S5033900 POMPMOTOR UPMO 15-60 130 3U

Vervangt / replaces / ersetzt / remplace / sostituisce :

S4108100	UPR 15-60 130 ZLS
S4741900	UP 15-50
S4749300	UP 15-60
S4774400	UPER 15-60 E

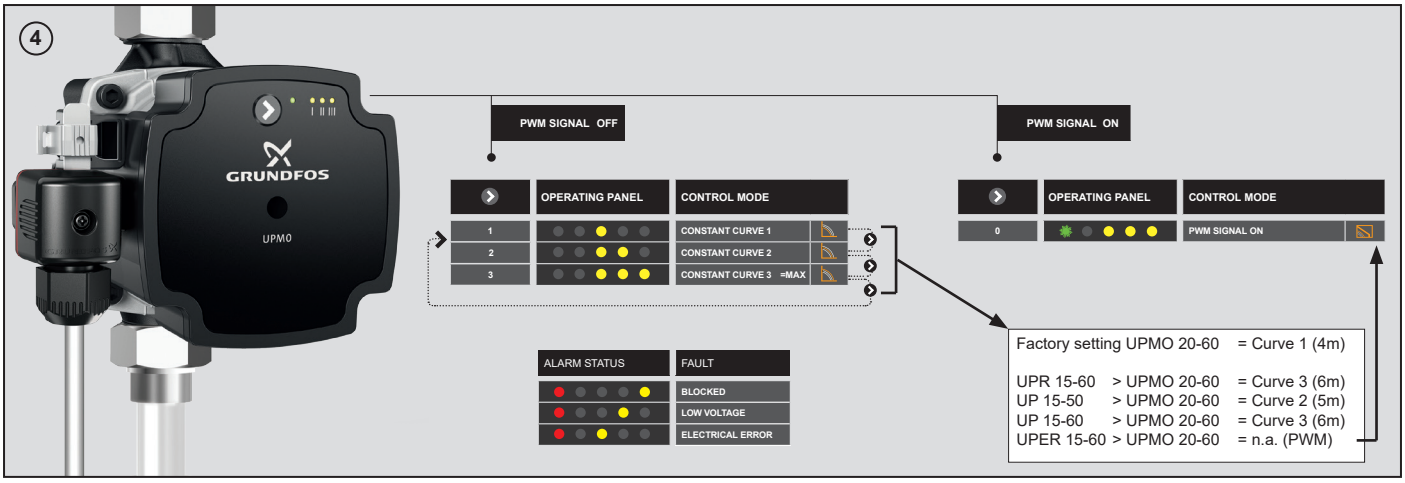
4
GRUNDFOS
UPM0
PWM SIGNAL OFF
OPERATING PANEL
CONTROL MODE
1
CONSTANT CURVE 1
2
CONSTANT CURVE 2
3
CONSTANT CURVE 3 =MAX
ALARM STATUS
FAULT
BLOCKED
LOW VOLTAGE
ELECTRICAL ERROR
PWM SIGNAL ON
OPERATING PANEL
CONTROL MODE
0
PWM SIGNAL ON
Factory setting UPMO 20-60 = Curve 1 (4m)
UPR 15-60 > UPMO 20-60 = Curve 3 (6m)
UP 15-50 > UPMO 20-60 = Curve 2 (5m)
UP 15-60 > UPMO 20-60 = Curve 3 (6m)
UPER 15-60 > UPMO 20-60 = n.a. (PWM)
